RE: **Recall Campaign Phase 7 Launch Notification**
2017120024 (Electric Steering Column)
SCM Ground
MY12-17 C-Class, E-Class, E-Class Coupe (204, 212, 207)

Campaign No. 2017120024, June 2018

Revision A

SUBJECT: **Model 204, 207, 212 Model Years 2012 - 2017**
Steering Column Module (SCM) Ground – electric steering column adjustment

Figure 6

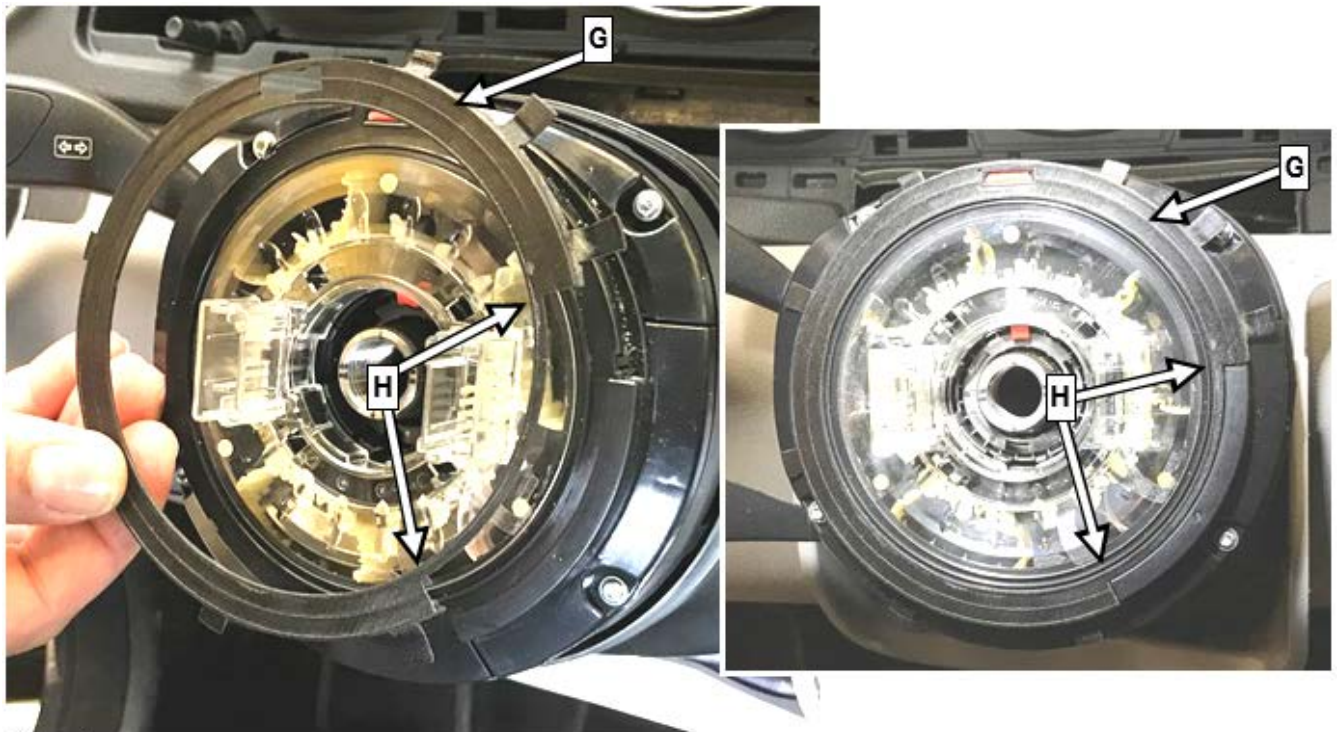
2. Subsequently position protective ring (**G, Figure 6**) on the installed Valeo steering column switch module.

i Protective ring is placed on loosely and then held in place when the cover (**E, Figure 5**) is mounted.

i Observe reference edges (**H, Figure 6**) of steering column switch module in relation to protective ring during assembly.

i Important! It is not possible to retrofit a protective ring for steering column switch modules if the protective ring is already cast on!

Figure 10

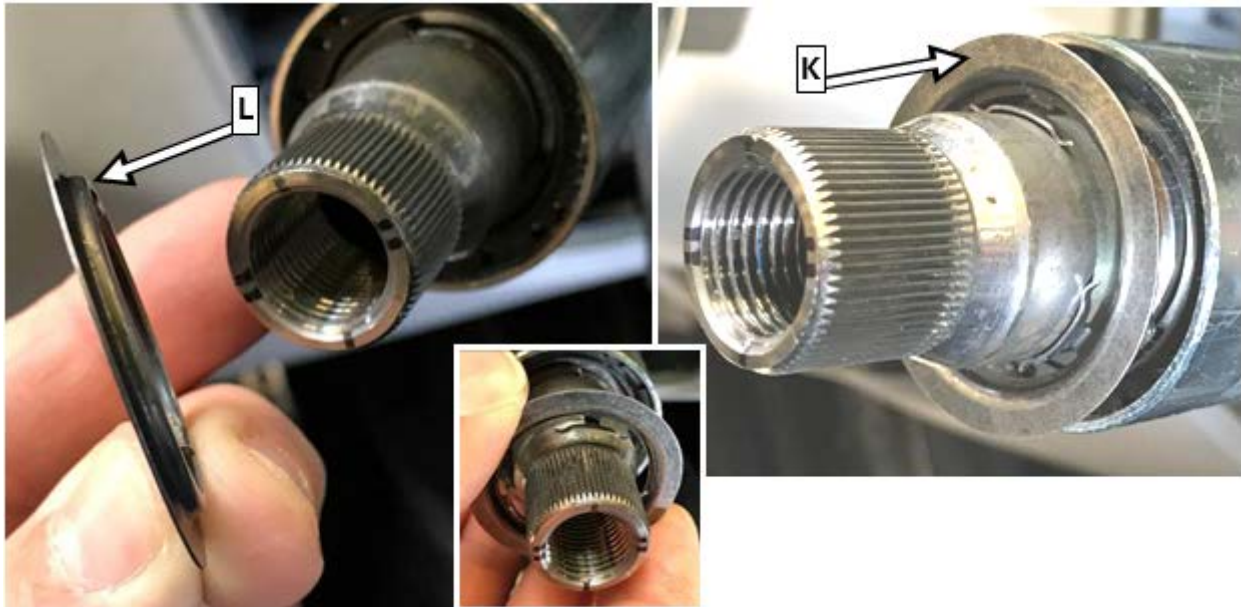
7. Slide Contact Bridge (**K, figure 10**) onto steering column until the end stop is reached.
- i** Note direction of installation: Lip (**L, figure 10**) on the contact bridge (**K, figure 10**) must face toward the direction of travel.

Figure 11

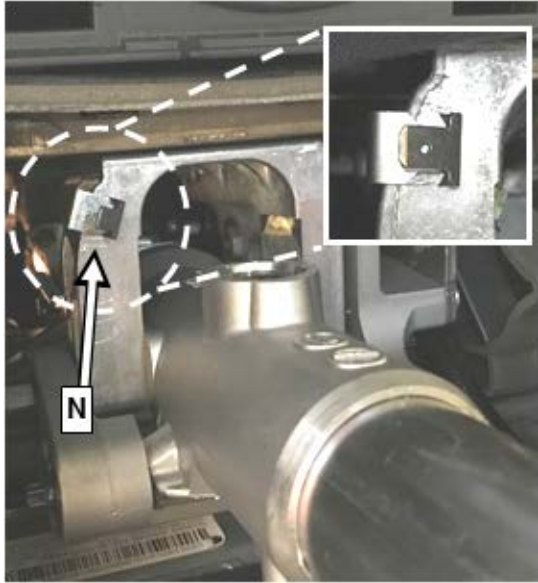
8. Subsequently install ground line (**M, figure 12**) on the electrically adjustable steering column.
- i** Slide the contact clip (**N, figure 11**) above the left horizontal crossbar (**O, figure 12**) onto the true vertical rib of the steering column.
- i** Important: No other assembly position is permissible!
- i** Slide the ground line (**M, figure 12**) (angled downward) onto the contact clip (**N, figure 11**).
- i** Remove the screw (**P, figure 13**) and tighten the ground line with the flat side of the eyelet and a new screw onto the steering column.
- i** Before tightening the screw (**P, figure 13**), position the ground line's eyelet at a 90° angle to the steering column (**figure 13**).
- Nm** Screw (**P, figure 13**) on the steering shaft: **4 Nm**
